**TOWNSHIP OF HARRISON
GLOUCESTER COUNTY, NEW JERSEY**

**WASTEWATER FACILITY
OFFICE CONSTRUCTION**

NOTICE OF ADDENDUM NUMBER 2

ADDENDUM DATE: October 09, 2026

A202

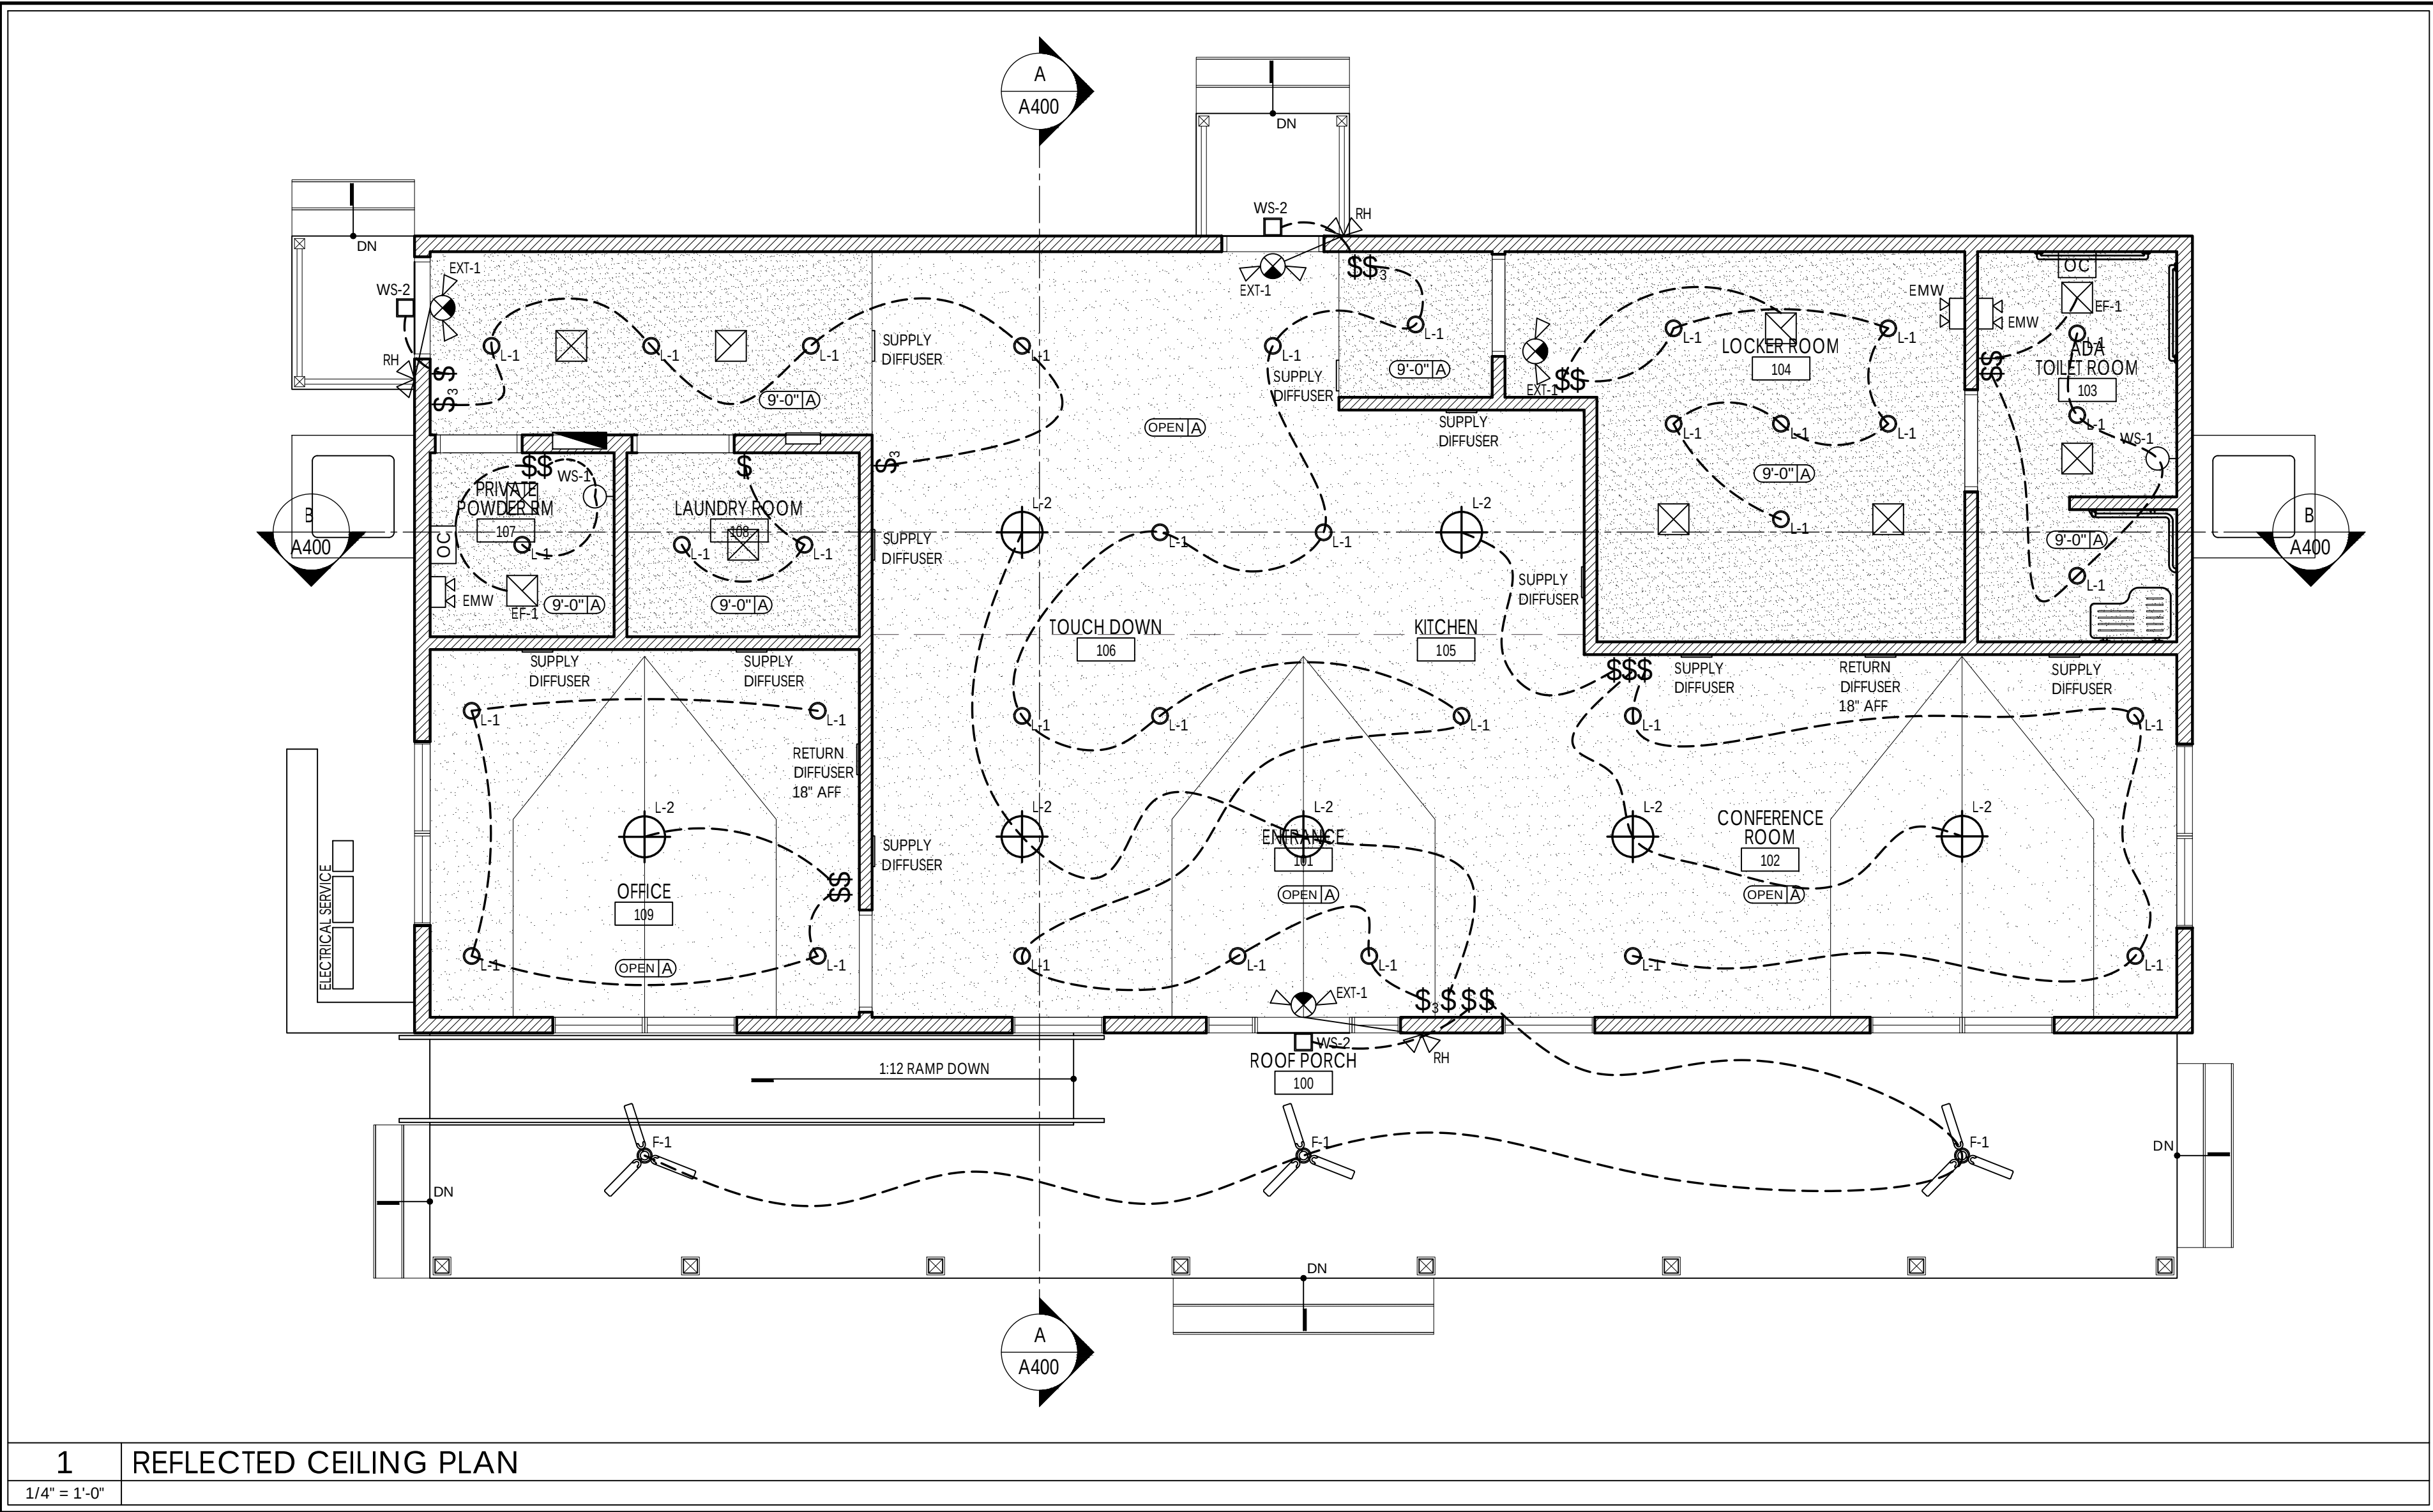
Reflected Ceiling Plan - A202

Revised reflected ceiling plan is attached to this addendum. Addition information added:

Exhaust fan spec

Exterior lights (building mounted)
